SOUTH FLORIDA WATER MANAGEMENT DISTRICT

TECHNICAL DOCUMENT TO SUPPORT THE CENTRAL EVERGLADES PLANNING PROJECT EVERGLADES AGRICULTURAL AREA RESERVOIR WATER RESERVATION

Draft Report

~~June~~July 28, -2020

Figure 1-6. The authorized Central Everglades Planning Project components.

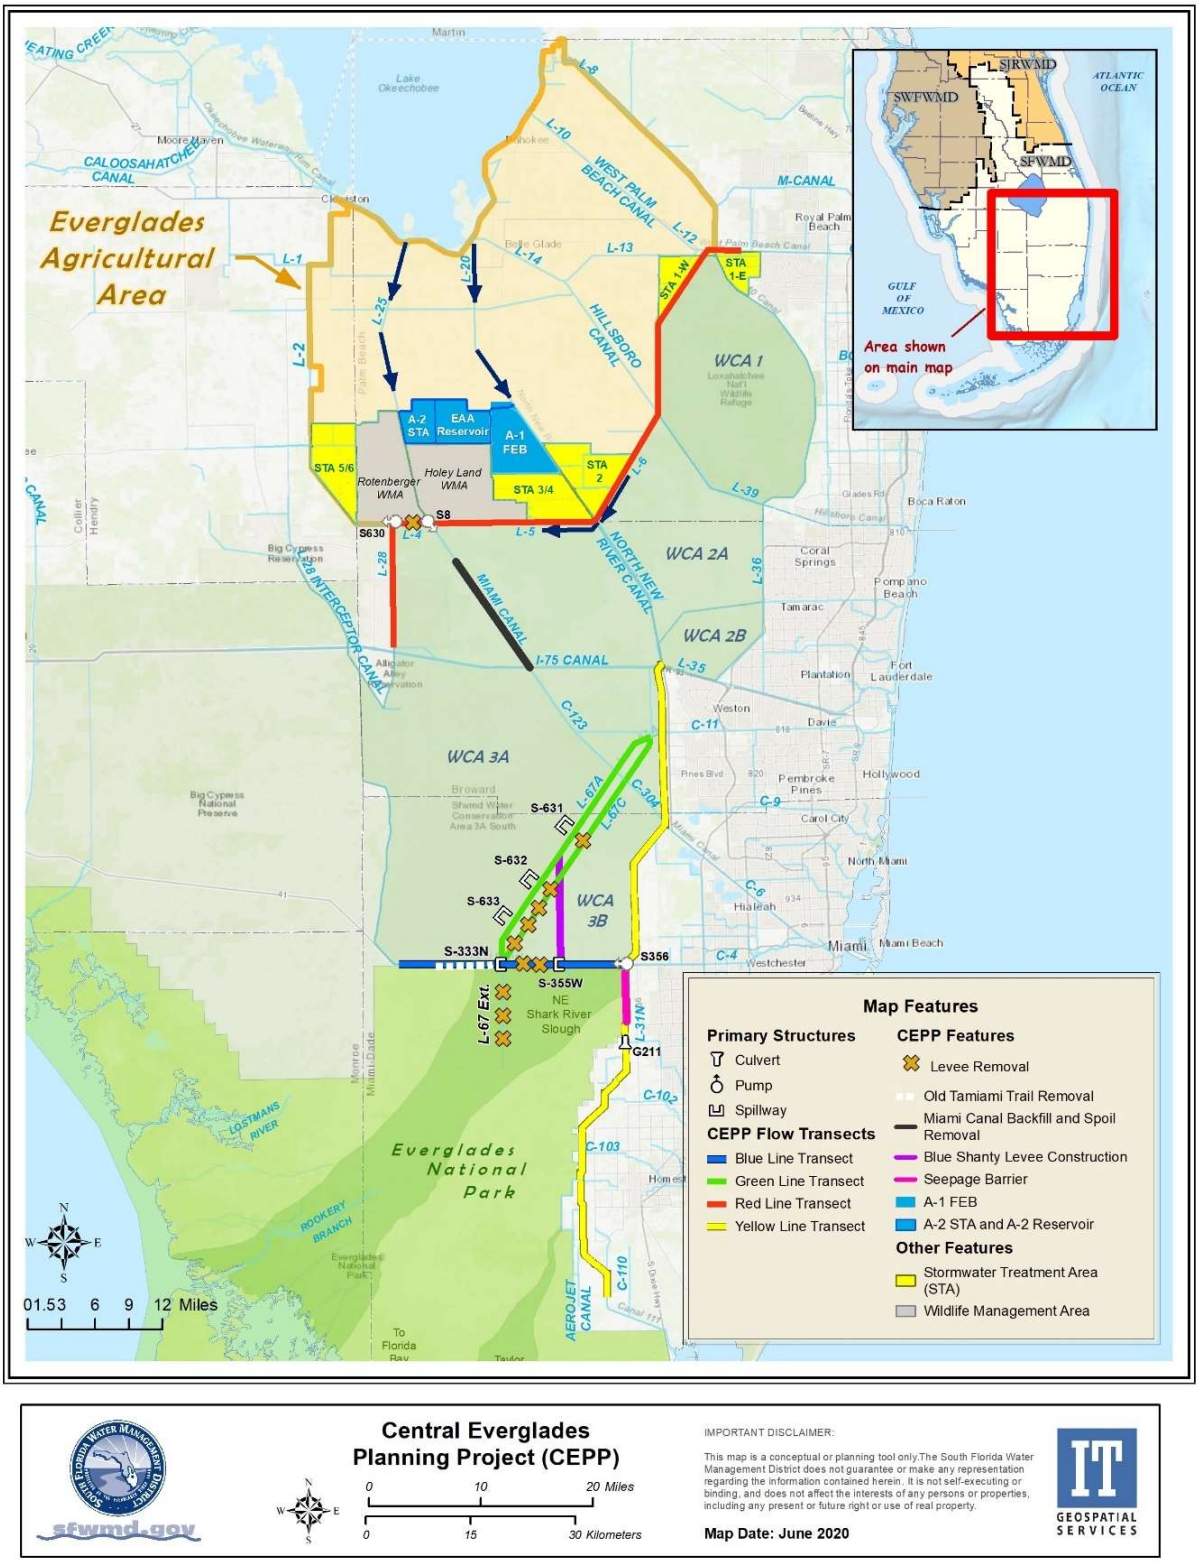
Comment No.	Commenter	Question/Comment	District Response
106	Dr. Nathan Dorn (Peer Reviewer)	In figure 1-6 the font is too small to read the features. I'd suggest you include two expanded figures to describe these regions or move the focus southward, putting Lake O at the very top of the figure.	**Brenda Mills**: Agreed. Figure 1-6 will be adjusted in the final technical document
107	Dr. Nathan Dorn (Peer Reviewer)	The third paragraph seems out of place? What does the LOSA water have to do with the lower east coast protective levee? From the way it reads I think the LOSA water has more to do with the canal levels and section 5.1.1.	**Walter Wilcox**: Agreed. The text will be clarified.
108	Dr. Nathan Dorn (Peer Reviewer)	What does the "original" CEPP mean? Is this the second phase of CEPP or an amended CEPP? Or is this proposal the original CEPP? Same adjective (original) is used on page 21 (section 4 intro).	**Brenda Mills**: The original CEPP refers to the project described in the PIR completed in December 2014, its Chief of Engineers report was signed on December 23, 2014, and authorized by Congress in Section 1401(4) of the Water Infrastructure Improvements for the Nation Act of 2016 (Public Law 114-322). The text will be clarified.

Figure 4-1. The Regional Simulation Model for the Greater Everglades and Lower East Coast Service Area (RSM-GL) domain with (a) gauges; and (b) flow transects (e.g., T5), and indicator regions (e.g., IR114).

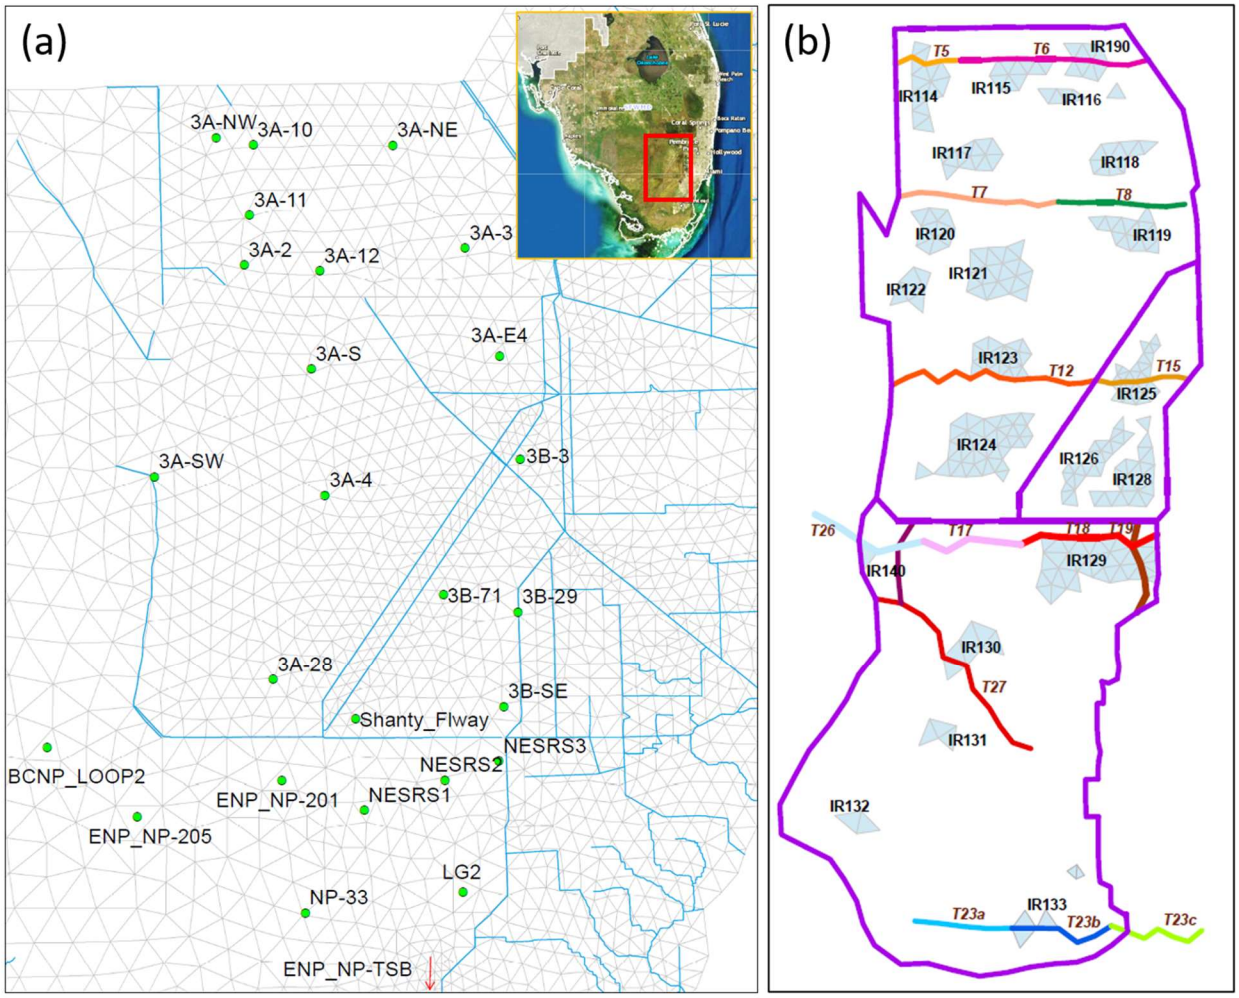
Comment No.	Commenter	Question/Comment	District Response
123	Dr. Nathan Dorn (Peer Reviewer)	Figure 4-1. This figure has small font and is difficult to read. Some of the gages in 4-1a are not used and some of the IR in 4-1b are not evaluated. Perhaps you could make this two figures and place them after 4-4. Figures 4-2, 4-3, 4-4 – It would be helpful to outline (with a dashed line) the central Everglades (area of primary focus here).	**Dong Yoon Lee**: We will recreate Figure 4-1 and use a full page of Figure 4-1a and Figure 4-1b. Regarding Figure 4-2, 4-3, 4-4, we are considering replacing the average rainfall year map with a long-term (1965-2005) average output.
124	Dr. Nathan Dorn (Peer Reviewer)	I believe that I am to read the results of the hydrologic analyses (4-2, 4-3, 4-4) as the outcome of all of the component parts of CEPP included in the evaluation - meaning with all parts in place that are listed in Figure 1-6 (e.g., A2 Reservoir, backfilled Miami Canal, Blue Shanty Levee, etc.). Is that correct?	**Walter Wilcox**: Yes, the reservation is necessary to protect the water that will be used by the FULL CEPP project, not just individual components or implementation phases.

Figure 4-2. Modeled hydroperiod during long-term (1965 to 2005) average rainfall (top) and dry (bottom) year conditions for the existing conditions baseline (left) and Alternative C240 (right).

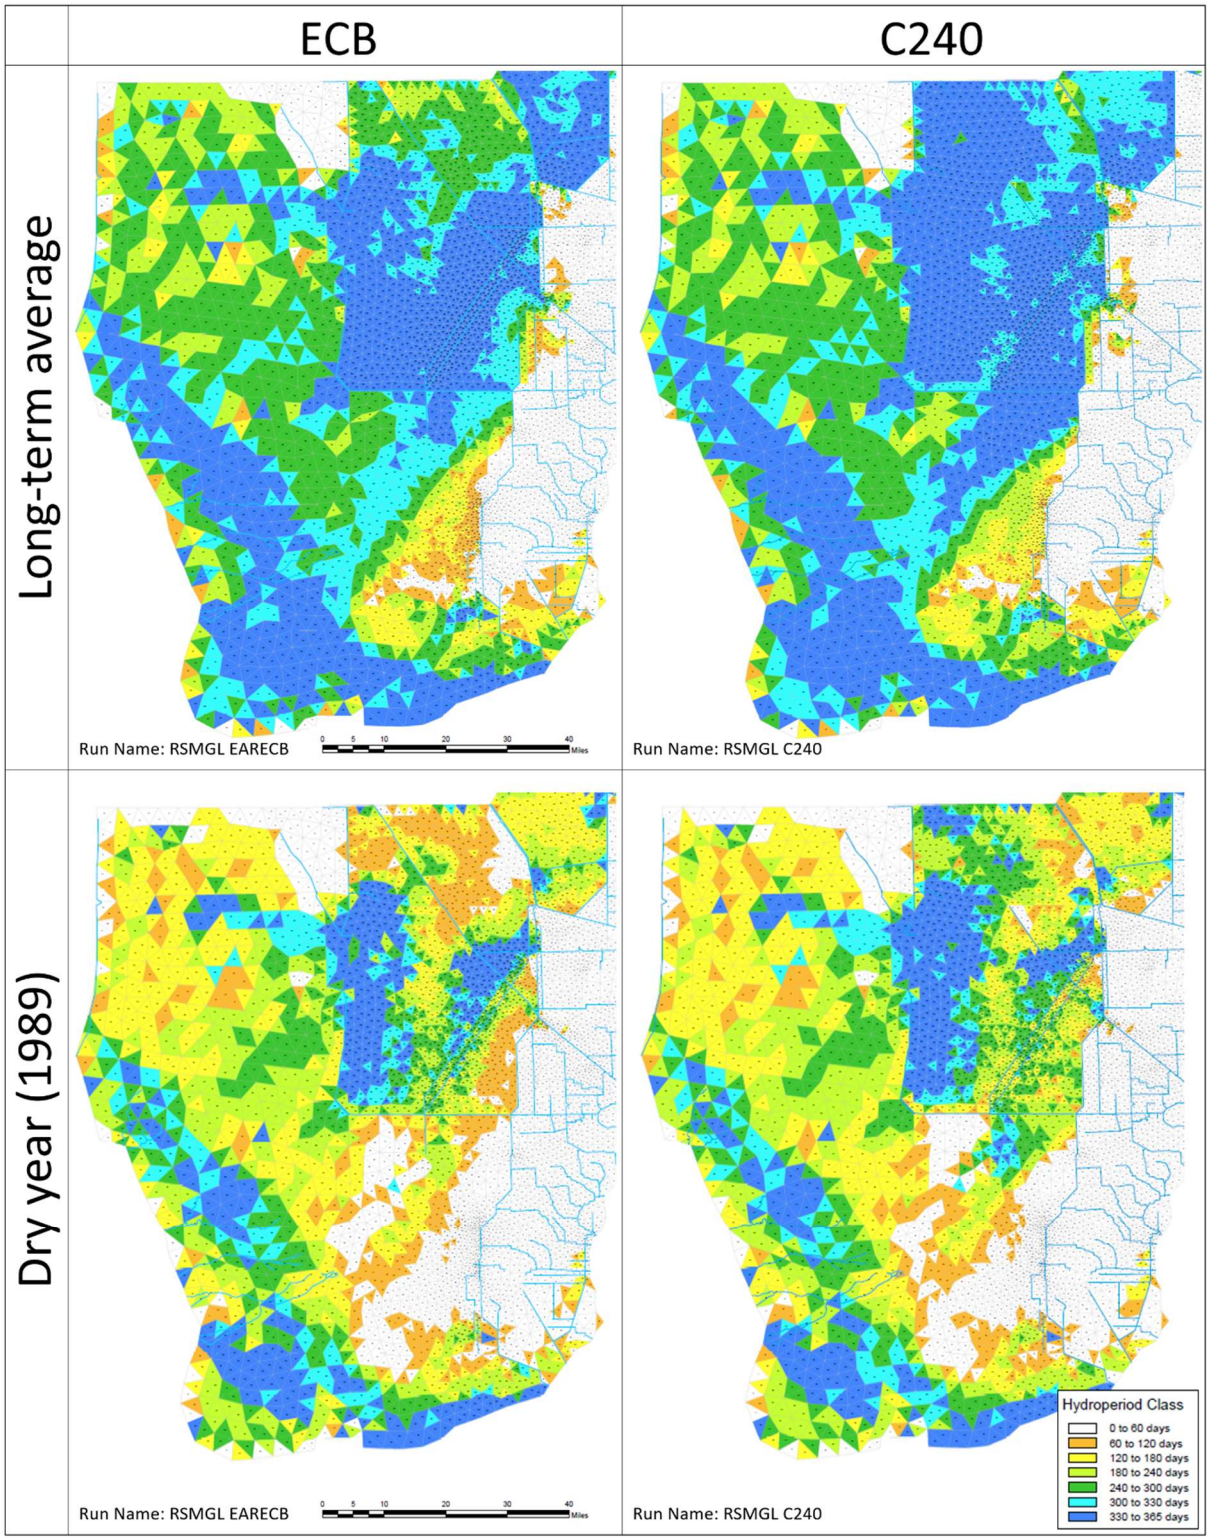
During the presentation period the SFWMD also responded to the concerns about WCA 3B. The general evaluation of hydroperiods, what was Fig. 4-2 in the original report, was replaced by a new figure in the public presentation that demonstrated hydroperiod shifts for a longer period of record than just an average or dry year. The updated figure clarified some small benefits of lengthened hydroperiods and deeper water in WCA 3B (south and central). The problem caused by additional drying out northern WCA 3B was acknowledged and discussed as an area for adaptive management and/or a future project.

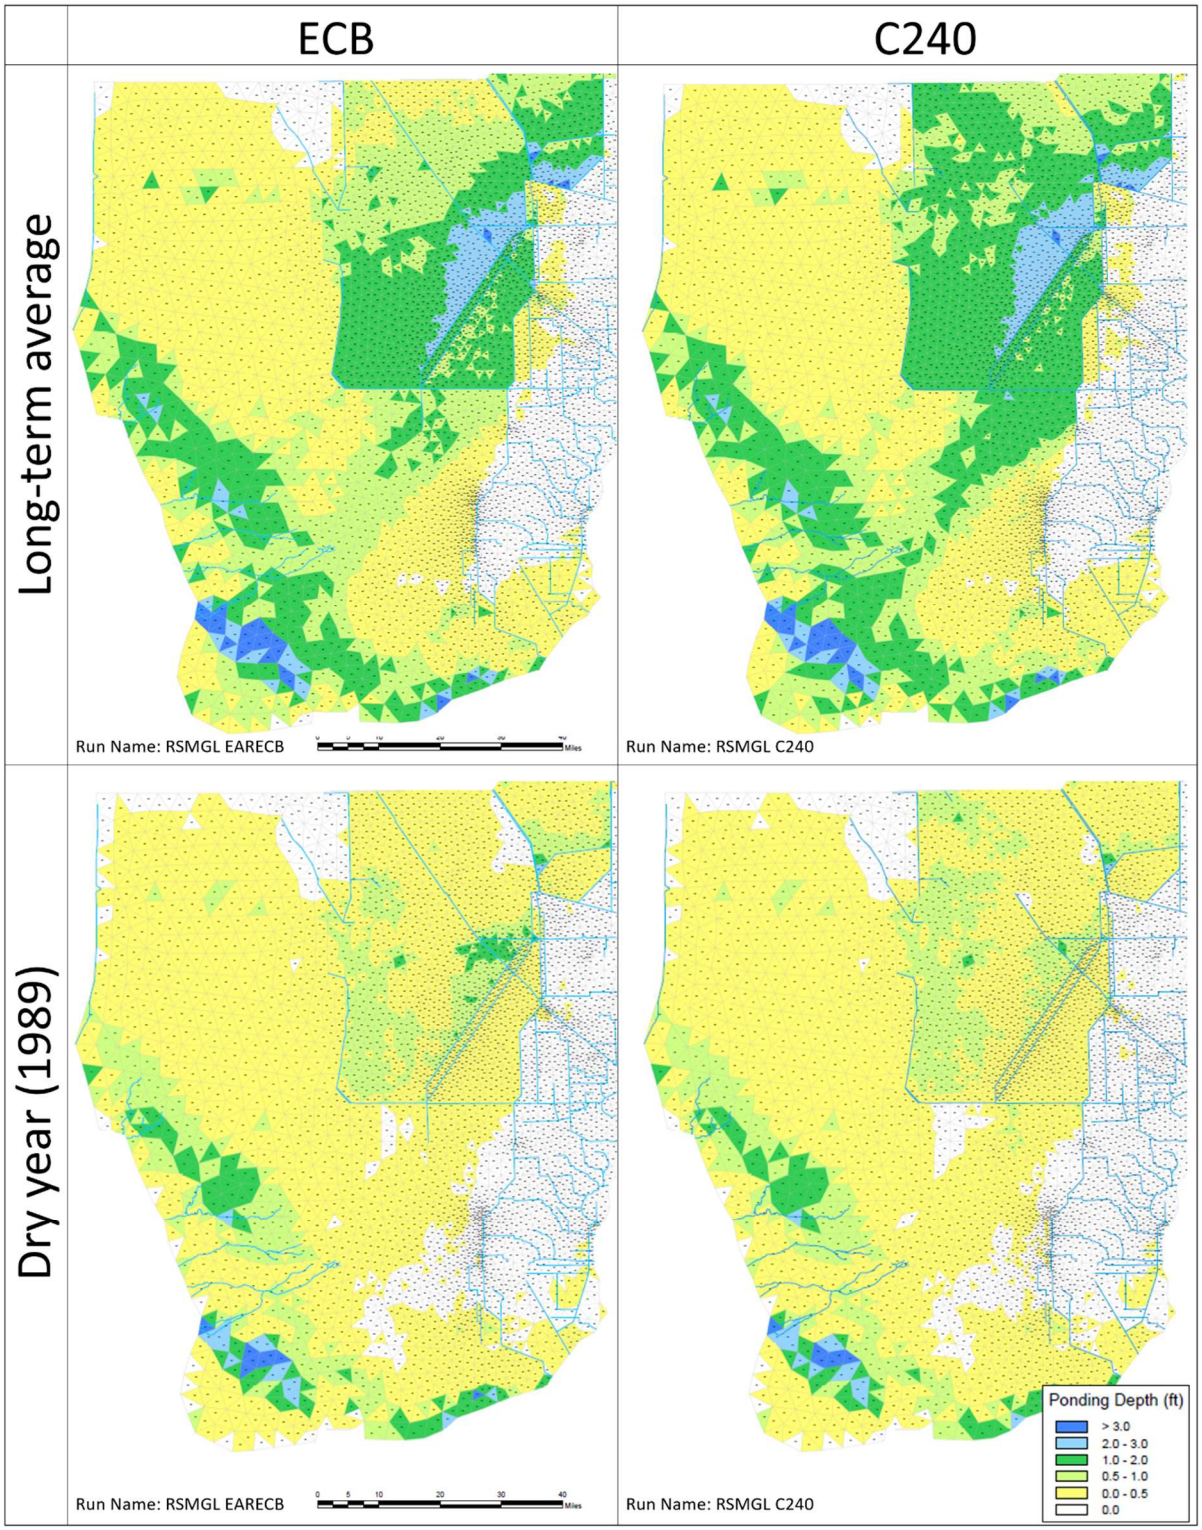
125	Dr. Nathan Dorn (Peer Reviewer)	I might have missed the definition, but can someone please explain the exact meaning of "ponding depth" (as reported in fig. 4-3)? Is it just average water depth at the site for the year (including below-ground/negative depth values)?	**Clay Brown**: The modeled ponding depth in Figure 4-3 represents the average annual ponding depth for an average rainfall year (1978) and dry rainfall year (1989). The annual average ponding depth is computed using simulated daily water levels for each model cell only when the water level is above land surface (i.e. only positive values) and computed as follows: When water level is > land surface elevation, then ponding depth = water level - land surface. Note the land surface represents an average within each model cell. The ponding depth for the year indicated is computed by accumulating the daily ponding depth for the water year and dividing by the number of days (in the year) where the ponding depth is greater than zero. **Dong Yoon Lee**: We will add a brief method of ponding depth calculation in the figure caption.

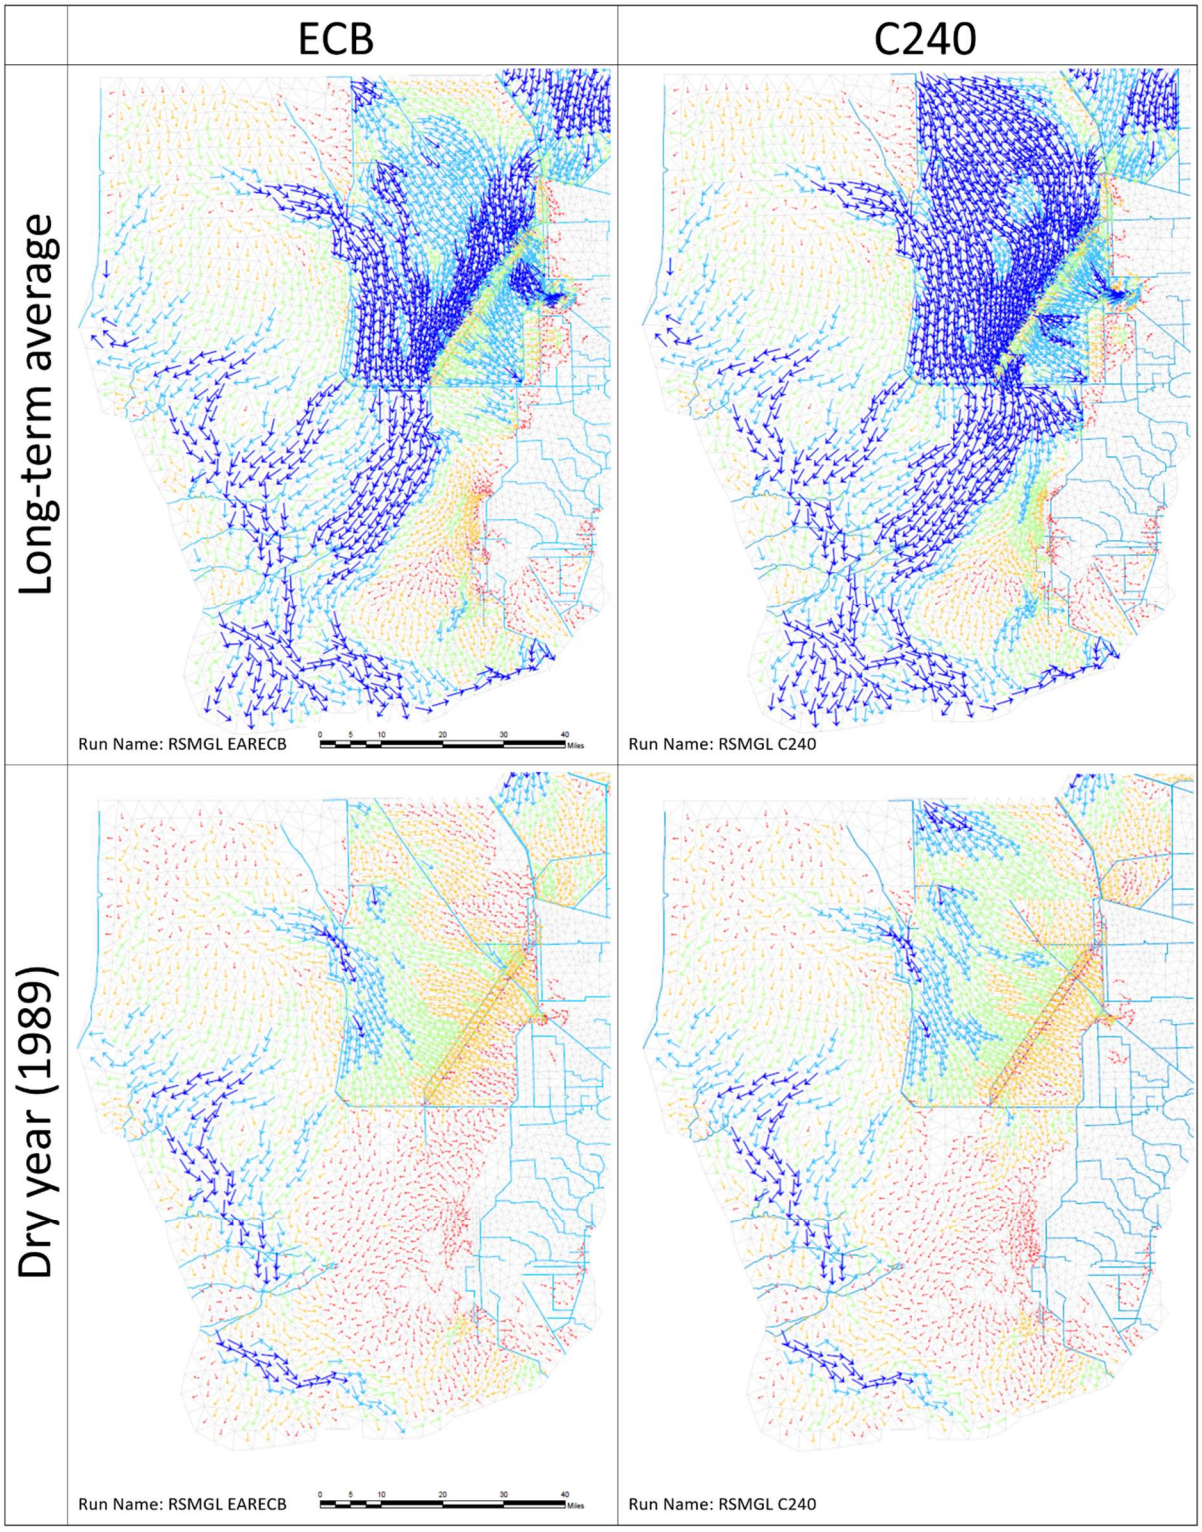
Comment No.	Commenter	Question/Comment	District Response
126	Dr. Nathan Dorn (Peer Reviewer)	Can someone please explain the meaning of the vector colors and arrows in Fig. 4-4? I assume vector size and color indicate something about expected volumes but I guess they could also indicate something about confidence in the direction?	**Clay Brown**: The modeled surface vectors in Figure 4-4 represents the average annual surface vectors for an average rainfall year (1978) and dry rainfall year (1989). The size and color of vectors represent the magnitude of flow within a model cell relative to all other model cells – the magnitude is not associated with any value. The colors are grouped according to magnitude (arrow size) – this is to help the reader identify the changes in magnitude. The direction of the arrow represents an annual average direction of flow using vector data for the corresponding year. The intent of the vector plots is to provide the reader with overall flow directionally and magnitude relative to other model cells. The reader should not attempt to compute flow (i.e. transect flows). **Dong Yoon Lee**: We will include the information provided by Clay Brown.

Figure 4-17. Water Conservation Area 3B Blue Shanty Flow-way stage duration curve.

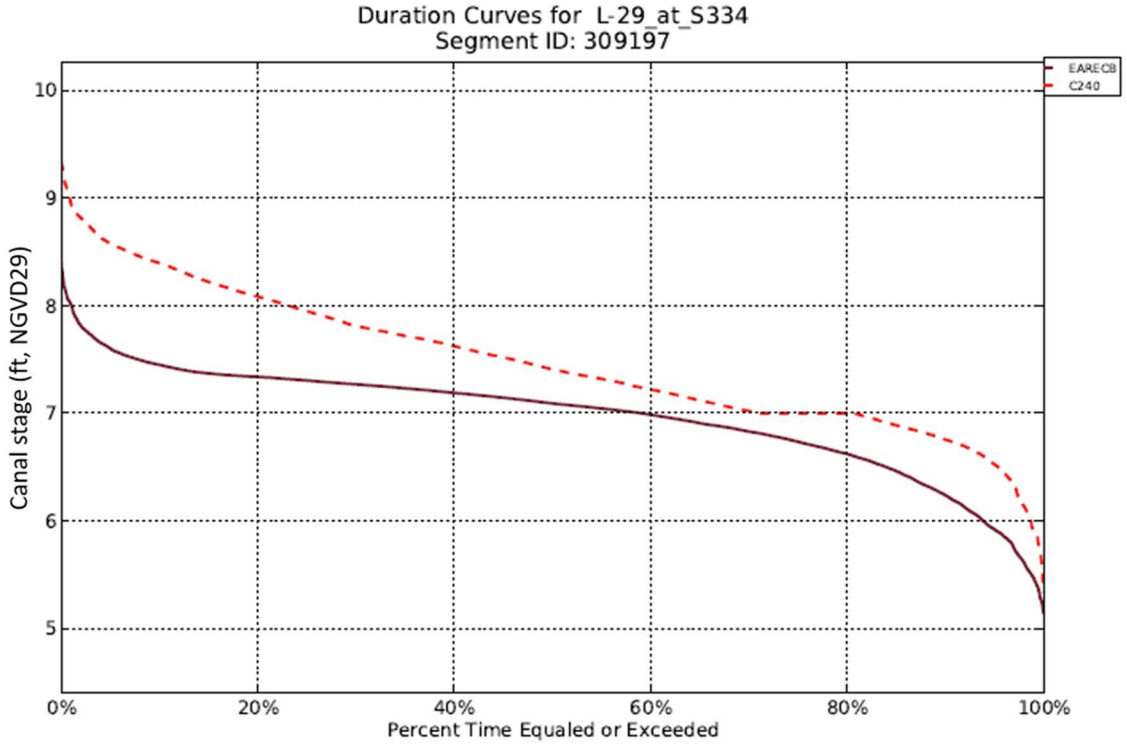
90	Dr. Donald DeAngelis (Peer Reviewer)	What is meant by Segment head (Figure 4-16)?	**Clay Brown:** Figure 4-16 is a stage-duration curve representing the headwater at structure S334. The vertical axis of the graph is canal stage with vertical datum units of NGVD29, ft. The term "segment" is a modeling term that refers to the discretization of a real-world canal system into modeled "segments". Output for canal segments can be reported as flow or stage; the term "head" is often used in place of stage. **Dong Yoon Lee**: We will revise the caption of Figure 4-16 (Segment head --> Canal stage).
